**CITY OF CLERMONT
PLANNING AND ZONING COMMISSION AGENDA
LOCATION: CLERMONT CITY HALL
685 WEST MONTROSE STREET
6:30 PM, Tuesday, September 7, 2021**

Item 1 - Ordinance No. 2021-021
Karma Housing Small-scale Comprehensive
Plan Amendment

Meeting Date		
Tuesday, September 7, 2021		
Agenda Item Name		
Ordinance No. 2021-021 <i>Karma Housing Small-scale Comprehensive Plan Amendment</i>		
Requested Action		
Recommend denial of Ordinance 2021-021.		
Staff Report		
The applicant is requesting a Small-Scale Comprehensive Plan Amendment (SSCPA) and an amendment to PUD Ordinance 2020-01 to increase the number of dwelling units from 36 units to 54 units on the 3.04 +/- acre project located southwest of the SR 50 and East Avenue intersection. The applicant is requesting this increase through the use of the Workforce Housing Density Bonus provision found in Section 122-358 of the Land Development Code. The applicant is requesting a Small-Scale Comprehensive Plan Amendment to change the future land use from Commercial to Master Planned Development. Policy 1.2.4 allows a density range of 12-25 units per acre in the Master Planned Development Future Land Use category. The current PUD is currently

PROJECT NUMBER
5571-20-002
DRAWING NUMBER
C5.0
DRAWING NAME
LAYOUT PLAN

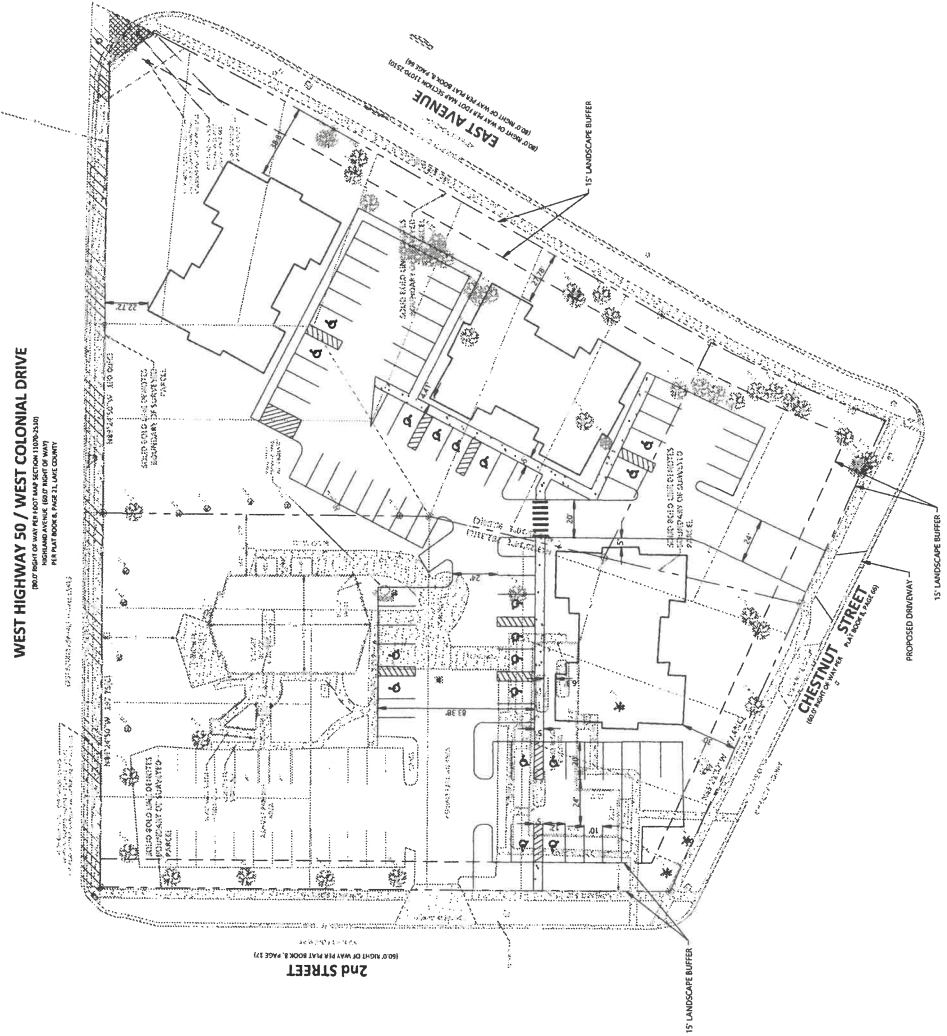
2. In reviewing the two applications, it was noted two different site plans were submitted. Please clarify the site plan that will be considered for the application and hearings. They have been enclosed for your review.

3. The setback requirement is 50 feet from SR 50 and one of the site plans does not meet this requirement for the apartment building. Please clarify which site plan is to be considered and if a waiver is requested for the setback.

5. The Planned Unit Development, based upon the unit count, shall provide an amenity. Please clarify the amenity provided.
6. Staff is very concerned, based upon the layout of both sites, of an auto turn analysis to provide adequate fire and emergency services to the project. Since the request is for a Planned Unit

Development, the conceptual site plan shall be close to what will be developed since it will have to maintain substantial compliance with what is approved by Council. Please confirm that the project can provide adequate fire and emergency services protection based upon the provided layouts.

10. Several items were noted on the site plans that will require further refinement or clarification. These items include, but not limited to, the total impervious surface ratio (ISR), adequate handicap parking, tree removal/replacement requirements, sidewalk connection to existing sidewalks, and if cut/fill is requested. Staff is concerned with the refinement of these items due to the site being proposed to be developed at the intensity and density presented.

RESPONSE: Please find the appropriate site/concept plan enclosed.

RESPONSE: A waiver from the 50' SR 50 setback is requested. The planned building is located 22.72 feet from the SR 50 ROW. It is noted the existing building is located closer than 50' from the SR 50 ROW, and that the City considered (but did not adopt) design guidelines for a portion of the SR 50 corridor that allowed (even required in some cases) setbacks of less than 50'. This 'building first' planning practice has been considered favorable over the large paved parking areas that would otherwise occupy the space.

RESPONSE: Please find the enclosed Turning Performance Analysis, specifically the auto turn analysis with the Clermont Fire Truck.
